TO: Mercedes-Benz Dealer Principals, General Managers, Sales Managers, Service Managers, Parts Managers	FROM: Gregory Gunther, Senior Manager, Vehicle Compliance and Analysis, Engineering Services
RE: <b>Recall Campaign Launch Notification</b> <b>Replace Fuel Pump Delivery Module - Wave 6</b> <b>MY21-23 C-Class, E-Class, CLS, S-Class, SL, GT, GLC, GLE, GLS and G-Class (205/206, 213/238, 257, 223, 232, 290, 253, 167 and 463 platforms)</b>	DATE: May 31, 2024

<b>Campaign No. :</b>	<b>NHTSA ID / CA DMV :</b>	<b>Campaign Desc. :</b>	<b>Replace Fuel Pump Delivery Module – Wave 6</b>
2023070012	23V445	23P4790205

Revision F: 08/12/2024

## **Replace Fuel Pump Delivery Module – Wave 6**

**Figure 2**

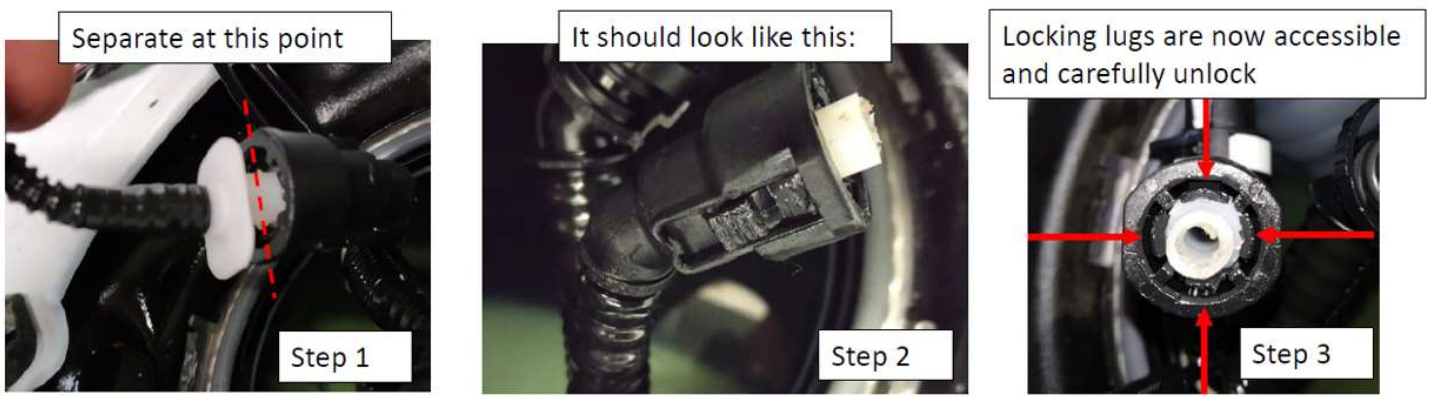
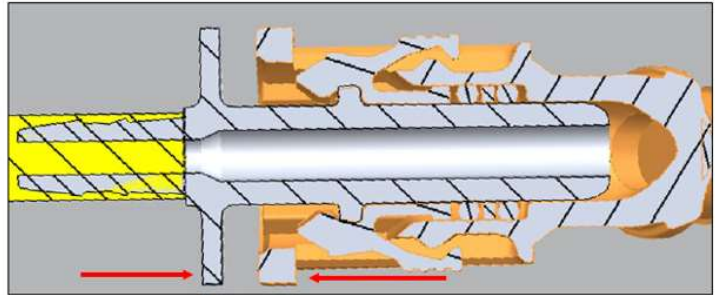
**i** Only model 206, 232: Note on disassembly of suction jet pump drive line quick connector. The procedure step 1-3 should only be performed when the quick disconnect is not working (**Figure 2**).

Squeeze the QC connection by at least 1mm, then unlock the latching lugs. If this is not possible. Step 1 -3

**Figure 3** (release corresponding connector and disconnect the contacts)

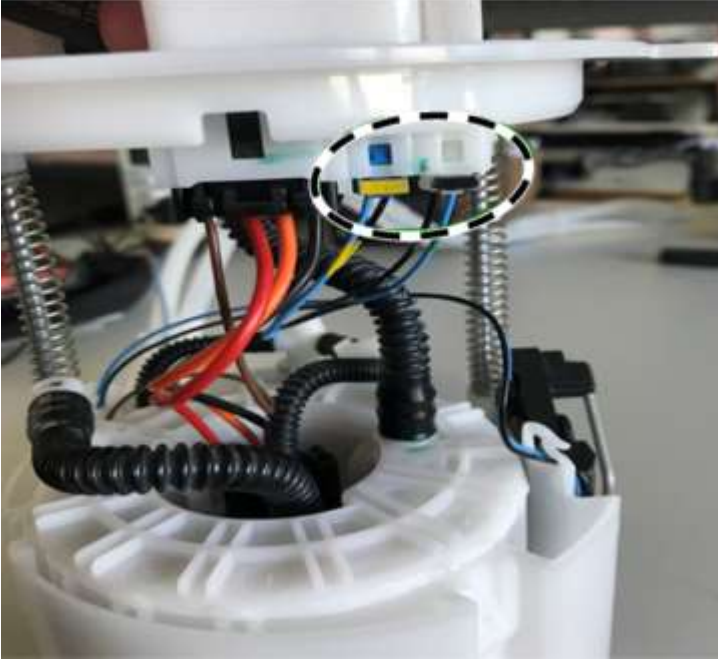
**i** Delivery modules that are delivered **without float-and-lever sensor** must be modified. (Figures 3-5)

**Figure 4** (remove lines from routing clip)

**Figure 5** (using a screwdriver, carefully push float-and-lever sensor housing away from module housing and at the same time push float-and-lever sensor housing upwards.)
